PRODUCT INFORMATION BULLETIN

Date: September 11, 2017
Number: 12046
Division: Genie®
Product Family: Residential Opener Service Parts
Product Series: Circuit Boards
To: All Genie Professional Line Wholesalers, Dealers and Installers
Re: Replacement Circuit Boards (Rhine Units)

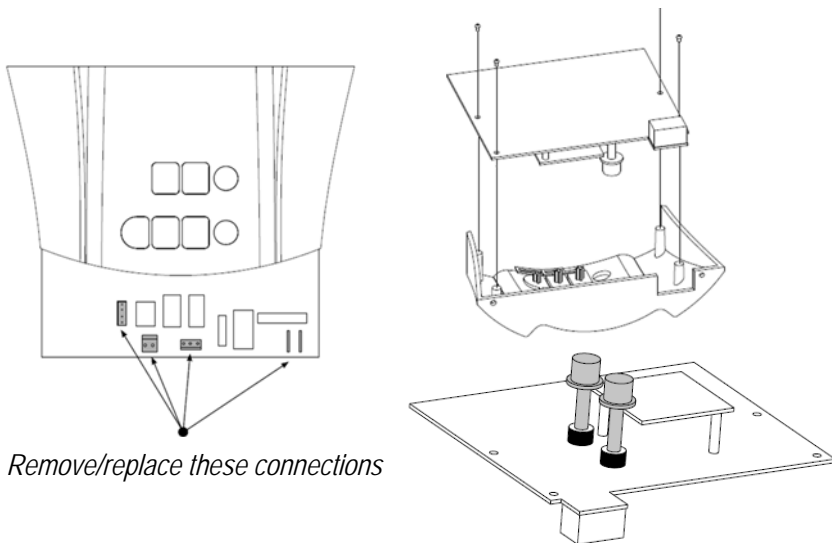
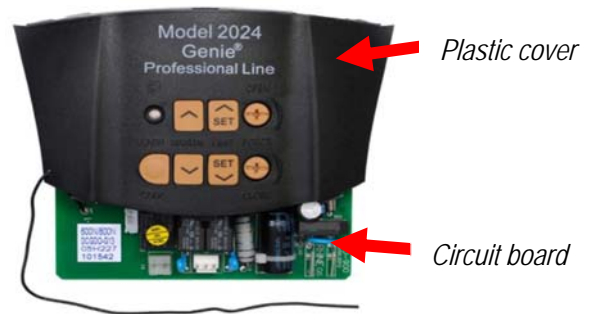
Previously, the below circuit board assemblies have always come with a plastic cover, such as the one shown in the image below (text by model). To help reduce the number of service board SKUs needed in the field, once these specific part numbers are depleted, they will no longer come with the plastic cover piece attached – it will be the board only.

The only added steps from the board with the plastic to the new part number is to remove 4 screws attaching the plastic to the board, gently pulling the antenna wire through and removing and reinserting force control shafts from the original board onto the new board.
